**BOROUGH OF AMBLER
COUNCIL MEETING AGENDA**

Re: MCPC # 22-0133-001
Plan Name: 25 North Ridge Avenue
(1 lot comprising 0.15 acres)
Situate: North Ridge Avenue and East Race Street
Ambler Borough

Reference: Final Land Development Plan Application Review
Colony Club Ambler LLC
25 N. Ridge Avenue
Tax Parcel #01-00-04222-00-7; Block 01044, Unit 030

Applicant
Response Letter

DEMOLITION PLAN
 SHEET 3 OF 9

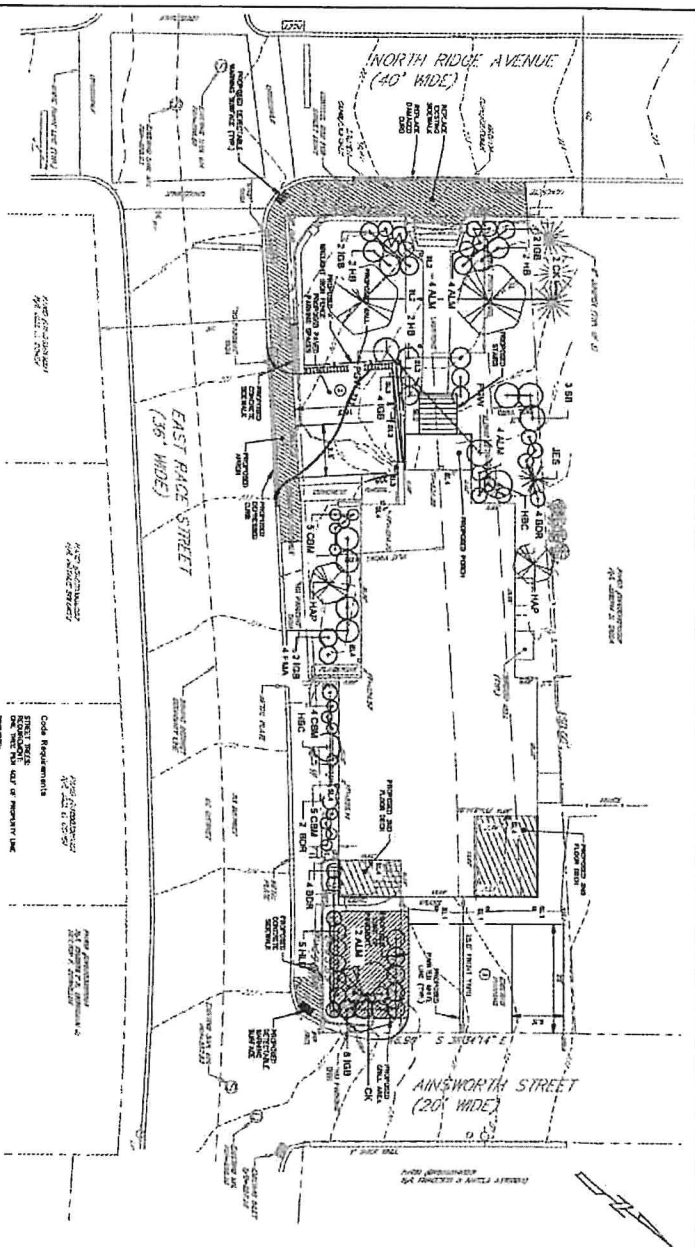
14. Top and bottom elevations of existing and proposed walls shall be included on the plans. Fall protection barriers shall be provided where existing and proposed retaining walls are 30 inches or higher.

16. The plans do not include top and bottom of wall elevations for the proposed wall at the two parking spaces off Race Street. We are not able to determine if adequate sight distance is provided for safe ingress and egress.

14. Top and bottom elevations of existing and proposed walls shall be included on the plans. Fall protection barriers shall be provided where existing and proposed retaining walls are 30 inches or higher. Existing = non-conforming; new retaining walls = conforming; Drawings updated Fall protection barriers Drawings updated; enlarged wall detail added showing spot elevs.

PROPOSED LANDSCAPING PLAN
SHEET 5 OF 9

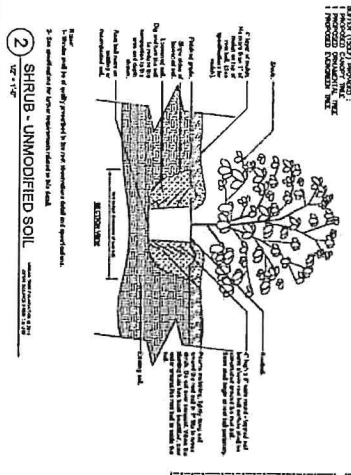
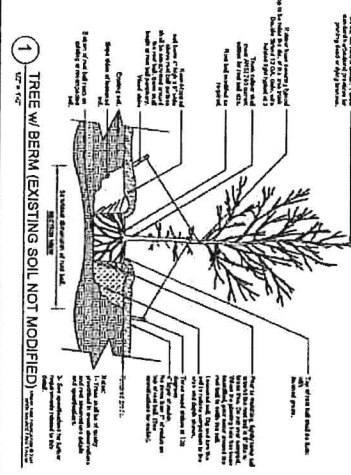
- C. Species. The only trees currently proposed for the site are three Butterfly Magnolias. We suggest the applicant refer to the list of trees in the SALDO §100.6 for recommended trees that can be used as street trees.

11. §22B-100.3 – Street trees are required at the ratio of 1 tree per 40 feet of frontage. Three street trees are required. Street trees shall be planted within the yard setbacks and within 15 feet of the right-of-way. The two proposed magnolia trees along Race Street qualify as street trees. However, the third magnolia on N. Ridge is greater than 15 feet from the right-of-way. The tree should be relocated, or a waiver granted.
12. §22B-100.7.2.B(12) – A schedule showing ordinance requirements and planting proposed for each category shall be included on the plan.

11. §22B-100.3 – Street trees are required at the ratio of 1 tree per 40 feet of frontage. Three street trees are required. Street trees shall be planted within the yard setbacks and within 15 feet of the right-of-way. The two proposed magnolia trees along Race Street qualify as street trees. However, the third magnolia on N. Ridge is greater than 15 feet from the right-of-way. The tree should be relocated, or a waiver granted. Drawings were updated; tree was relocated
12. §22B-100.7.2.B(12) – A schedule showing ordinance requirements and planting proposed for each category shall be included on the plan. Drawings were updated; schedule added
